Re: **Wire Fence CANYON* *Federal* ~~Utah~~ *21-1*
Burton/Hawks, Inc.
4-Well Program
South Uinta Prospect
Duchesne County, Utah

WIRE FENCE CANYON

TO: DISTRICT ENGINEER, O&G, SALT LAKE CITY, UTAH
SUBJECT: APD MINERAL EVALUATION REPORT
OPERATOR: Burton/Hawks, Inc.
LEASE NO. U-8895
WELL NO. No 21-1 Wire Fence Canyon - Fed
LOCATION: 1/2 NW 1/2 NE 1/2 sec. 21, T. 6S, R. 5W, USM
Duchesne County, Utah

No. 21-1 Wire Fence Canyon-Federal
NWNE Section 21, T6S, R5W
Duchesne County, Utah
U-8895

BURTON/HAWKS, INC.

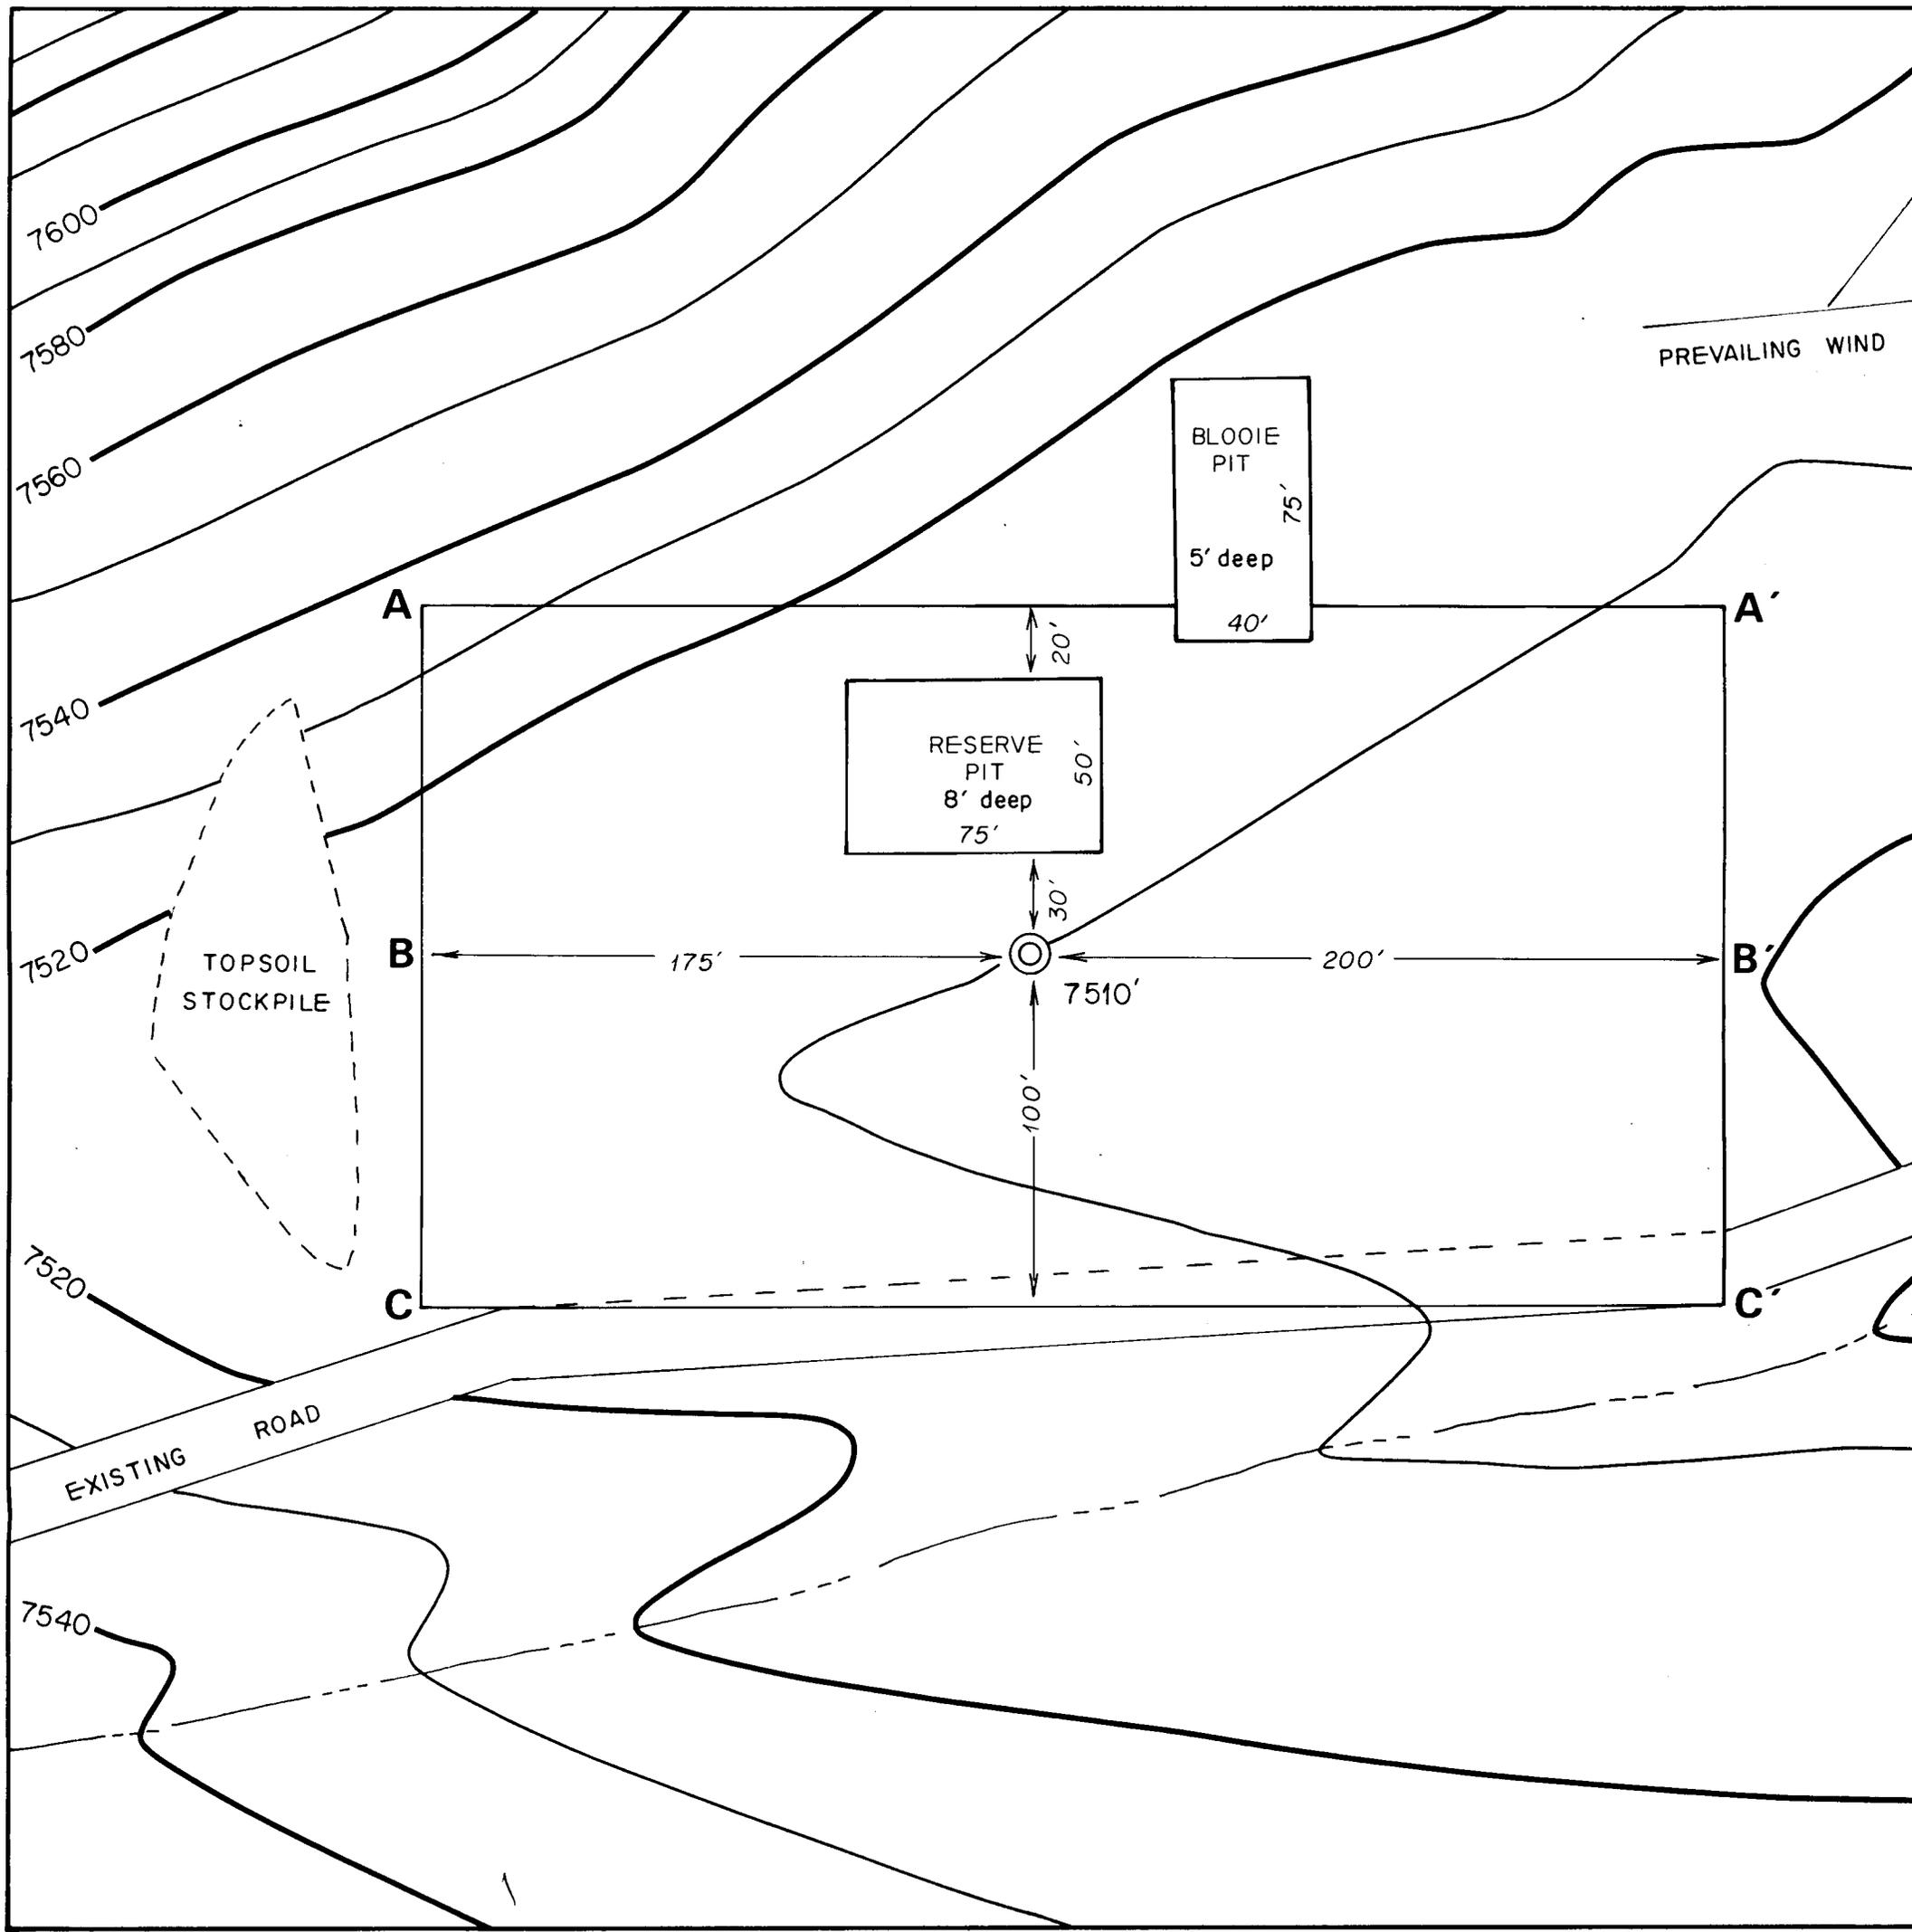
- (a) The wellsite and pad are moved 100 ft. south of their present location to mitigate cut and fill.
- (b) The reserve pit and blooie pit are rotated 180° about the wellsite to alleviate extensive cut and fill and prevent downhill seepage from the reserve pits across the wellsite. The reserve pit is to be elongated to dimensions approximately 30 ft. by 100 ft. and the pad shortened by 20 ft. on the east side to avoid a non-perennial drainage. The blooie pit is to be reshaped according to the design suggested by the dirt contractor and will be mostly on the southwest corner of the pad. It will be kept a minimum of 100 ft. from the wellsite.
